CITY OF ALBUQUERQUE

RE: **APS Montgomery Complex**
3315 Louisiana Blvd NE
Drainage Report and Grading Plan
Engineer's Stamp Date: 4/25/17
Hydrology File: G18D048

RE: APS Montgomery Complex; G18D048

Dear Mr. Peterson,
Wilson & Company has reviewed the comments provided in an email dated April 25, 2017 on the APS Montgomery Complex Project. **Below are the responses to the comments:**

HEADWALL TRASH RACK DETAIL

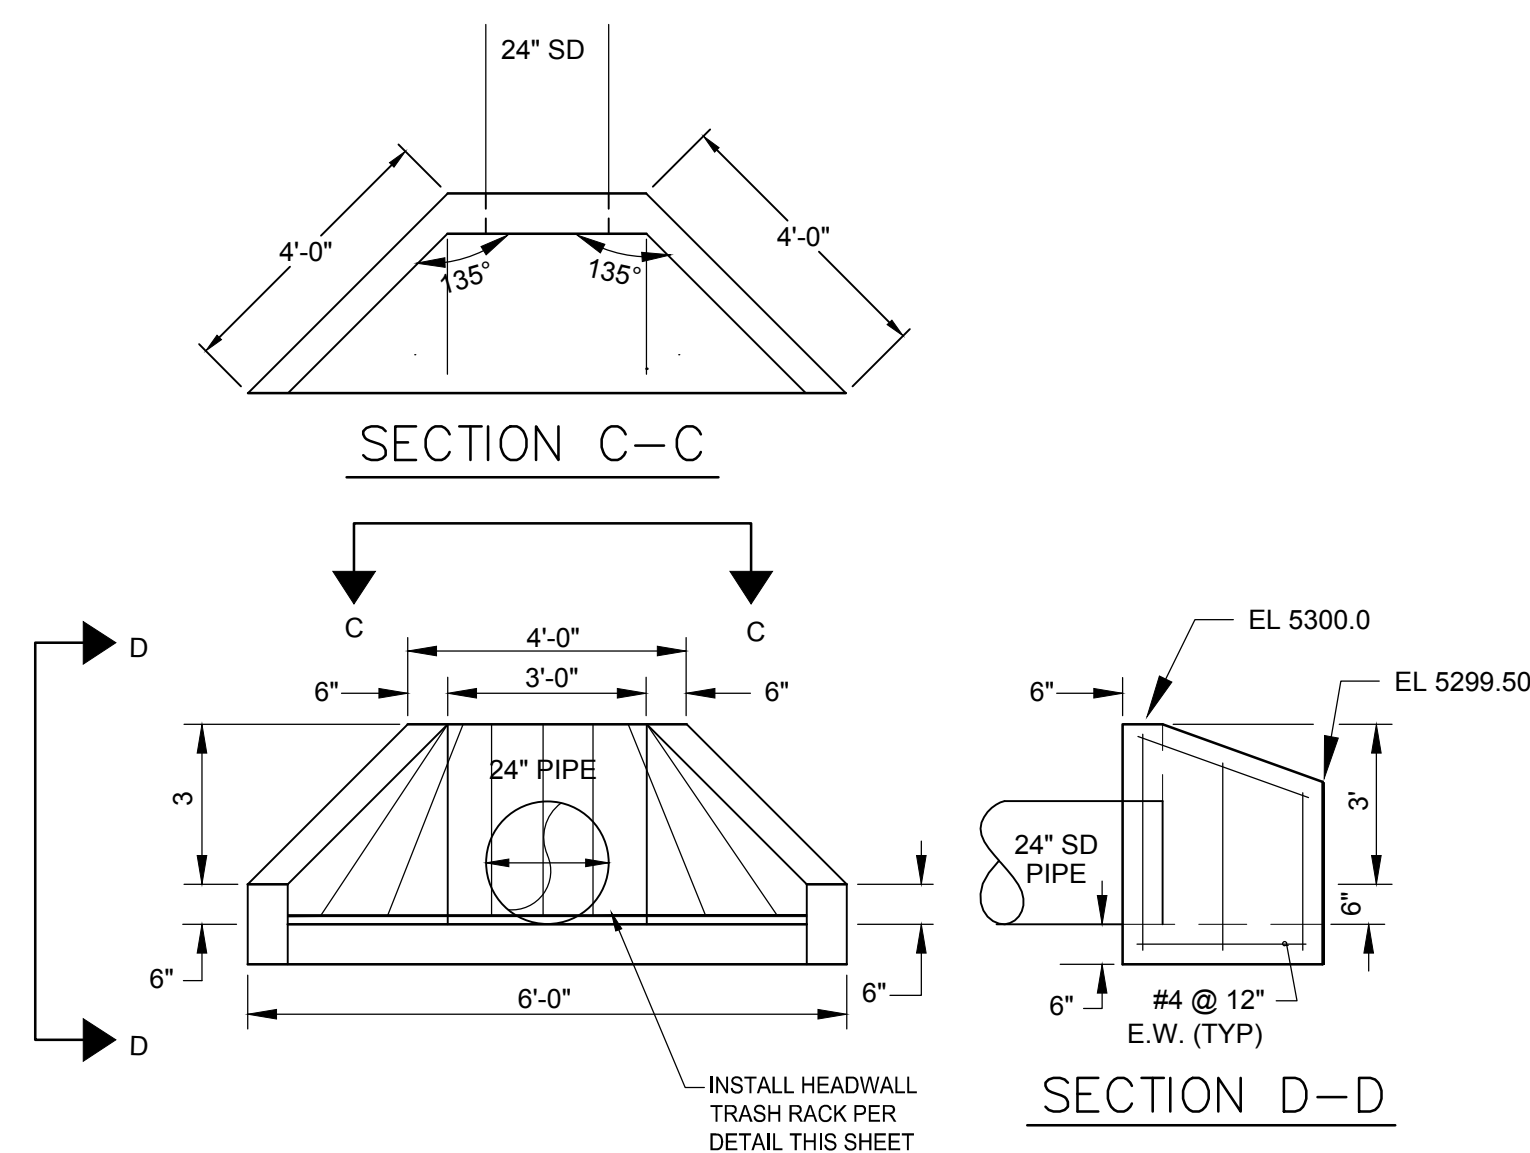
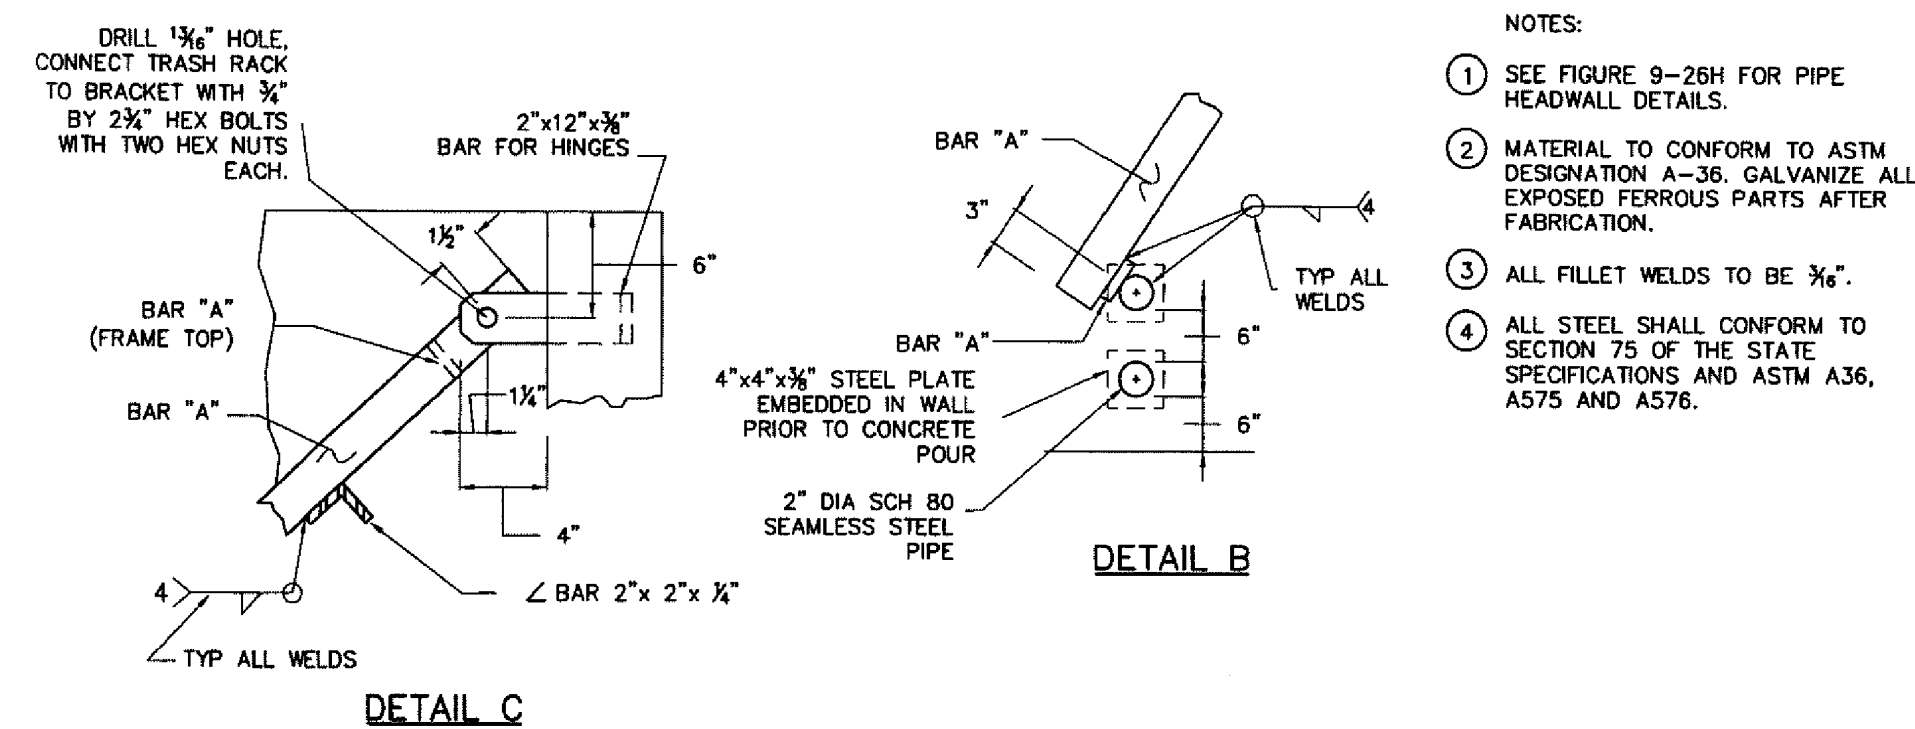
3. Pond 4. Provide inlet protection on the outfall end section to prevent accidental entry. **Trash rack added. See Detail sheet C502**
4. It is unclear how the storm water quality volume is being retained. The report references use of each ponds' dead storage, however the outlet culverts are all within 0.2 ft of pond bottom. Provide dead storage volumes and account for allowable error in construction finished grades (likely +/- 0.2 feet). **Bottom of pond elevation modified to 0.4 ft below outfall invert. First Flush volume of each pond noted on plan and Pond Summary Table.**

A6 **CMP RISER DETAIL**
SCALE: NTS

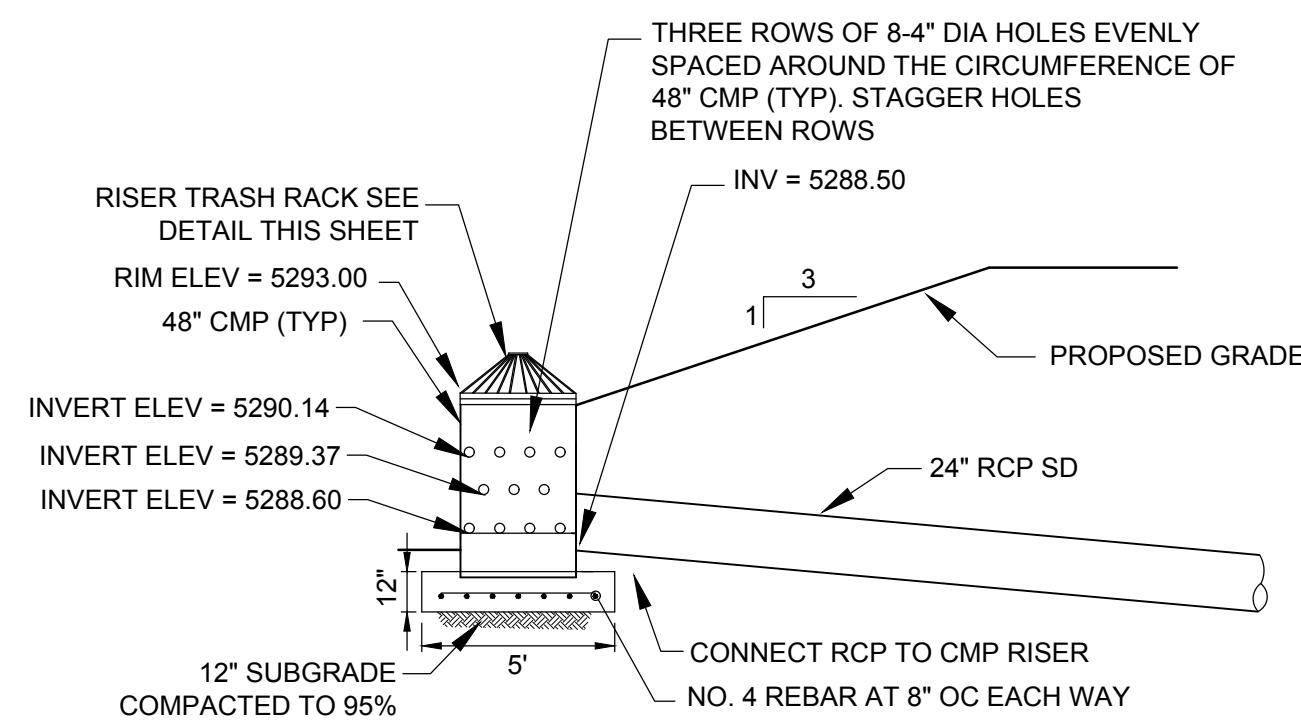
2. Pond 7. Provide inlet protection on the outfall to prevent accidental entry. Also include a water quality feature to prevent sediment from washing into South Hahn. **Riser added. See Detail sheet C502**

OVERALL GRADING & DRAINAGE PLAN

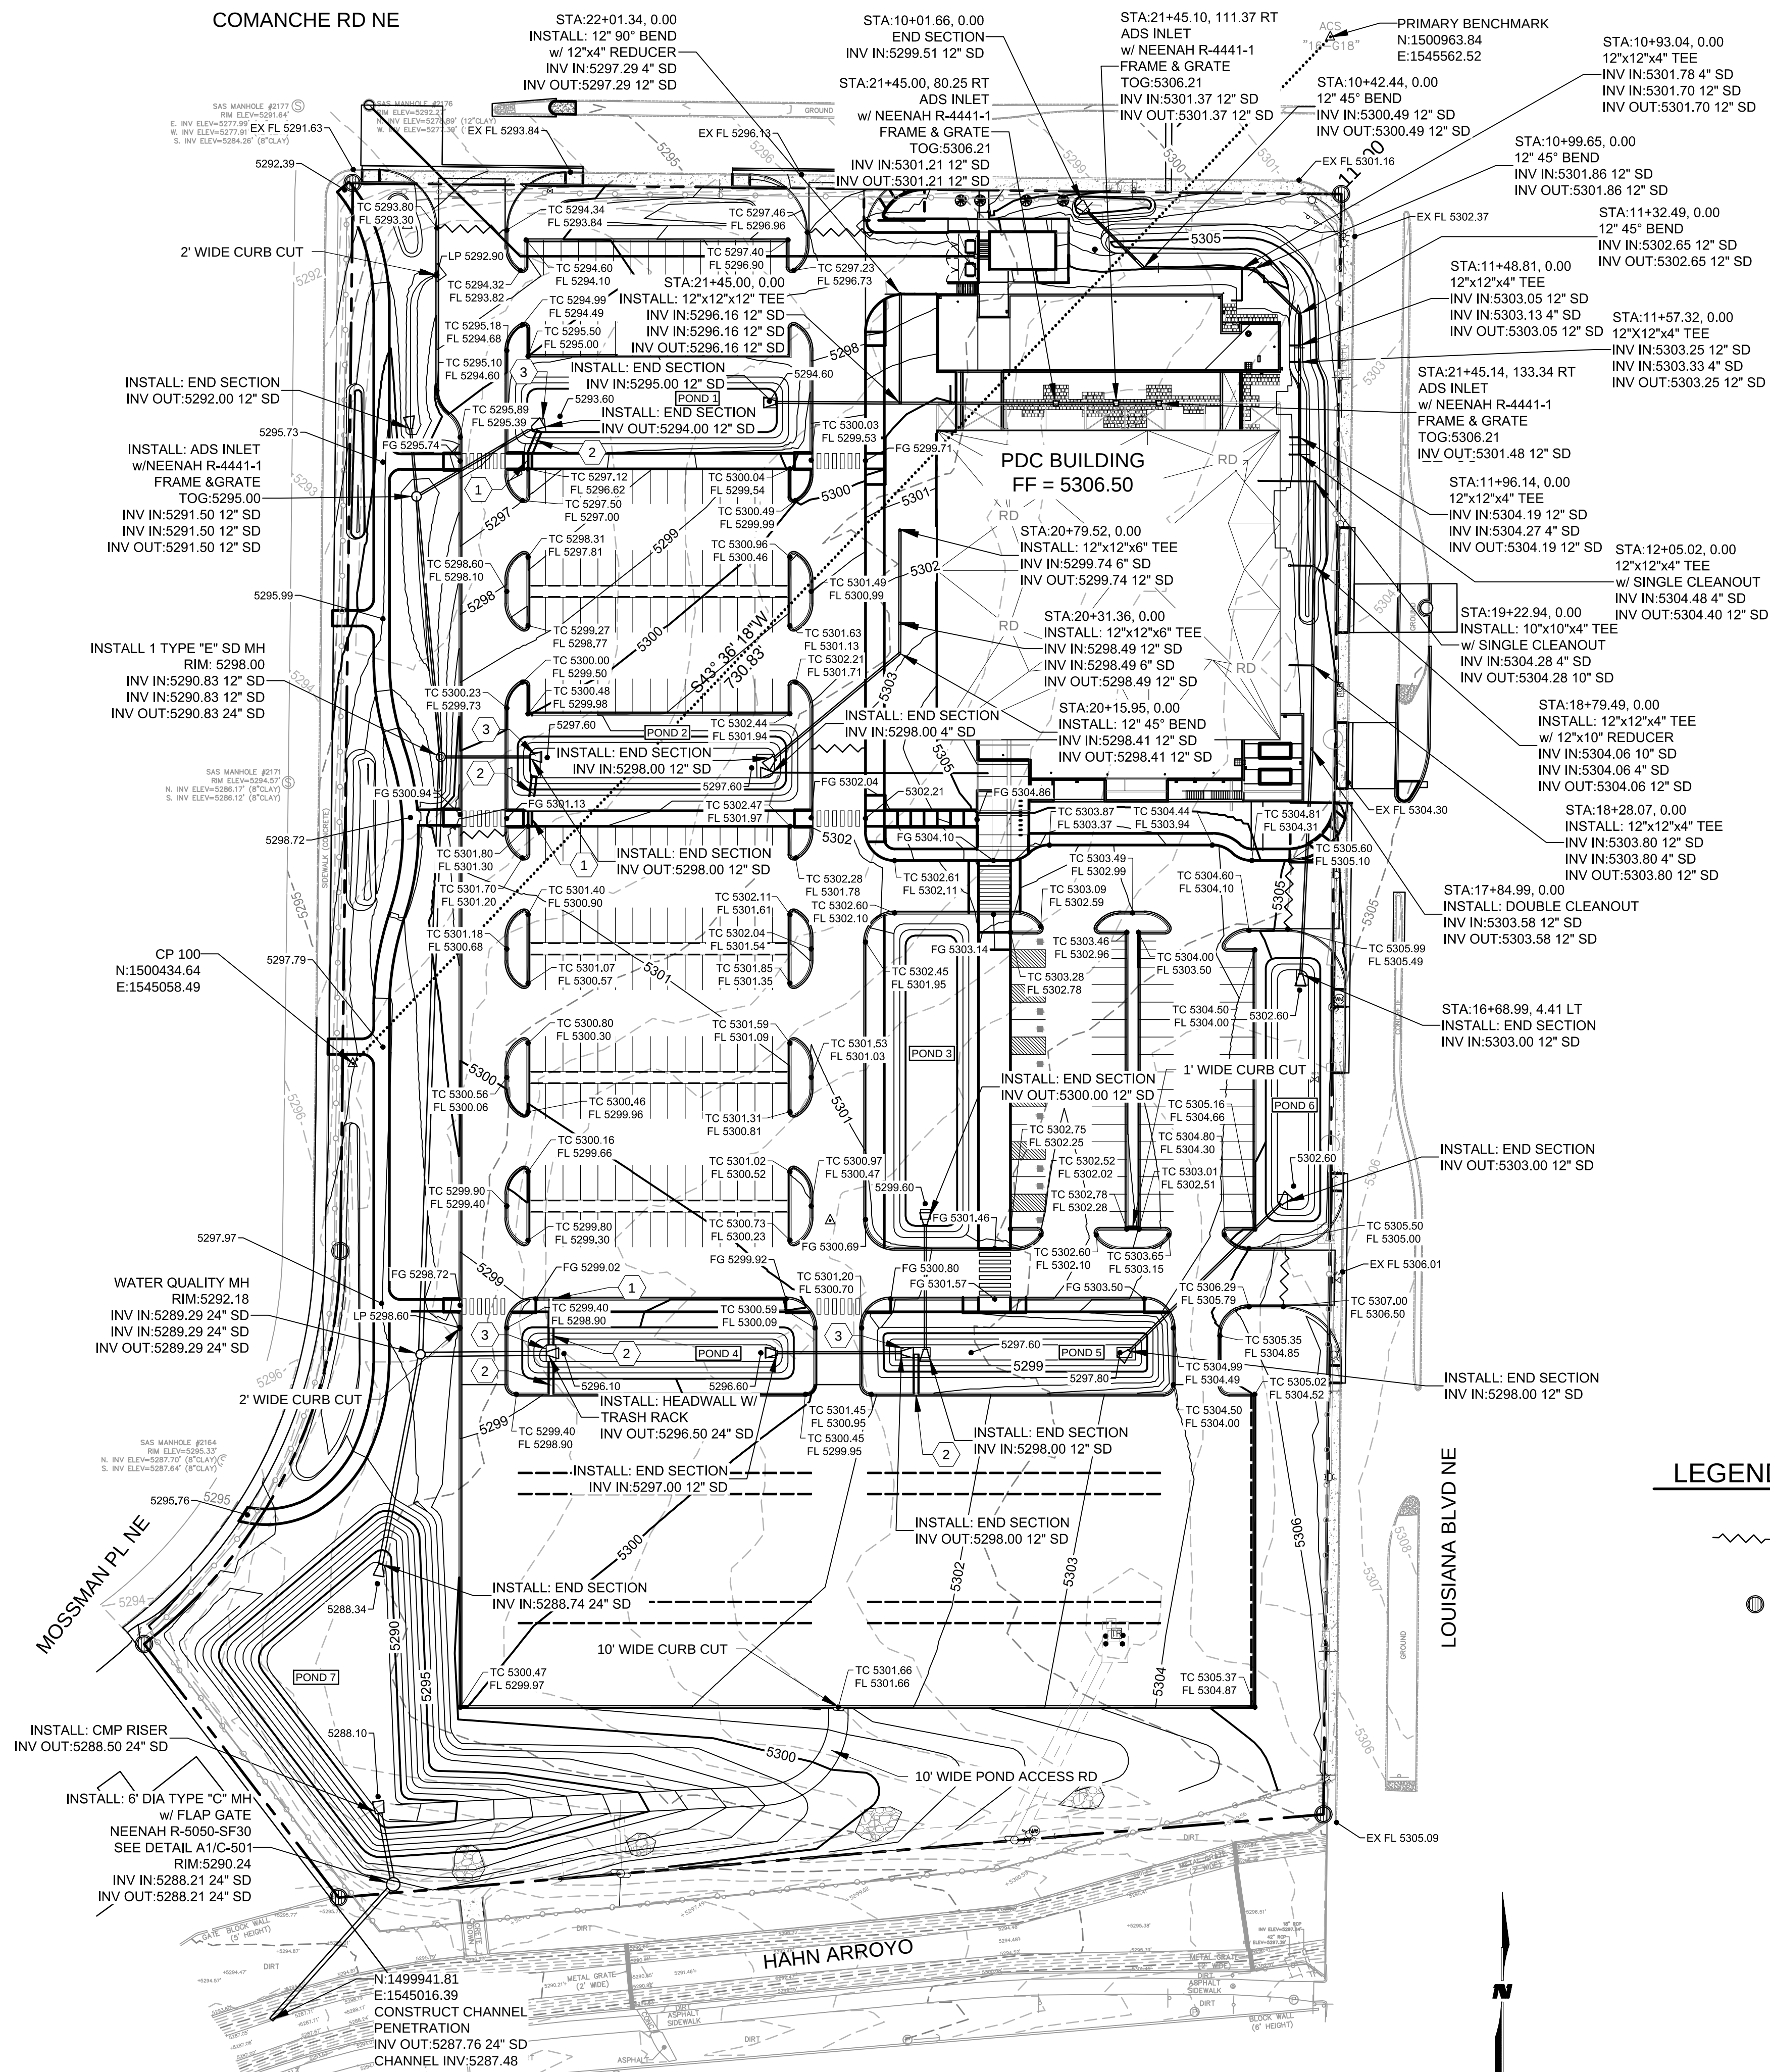
1. Provide finished floor elevation for the PDC building. Assuming the PDC building footprint is outside the Zone AO on Comanche, state so in the report (section 1.3). **Note added to Overall Grading & Drainage Plan and report.**

7. The penetration into South Hahn may be performed under S0-19 or mini- work order. State how the work will be performed on the Grading Plan. If using S0-19, include standard S0-19 notes. Prior to beginning work, notify Jason Rodriguez with Municipal Development to coordinate an inspection schedule (jtrodriguez@cabq.gov). **Penetration will be performed under work order 772071. Note added on Overall Grading & Drainage Plan.**
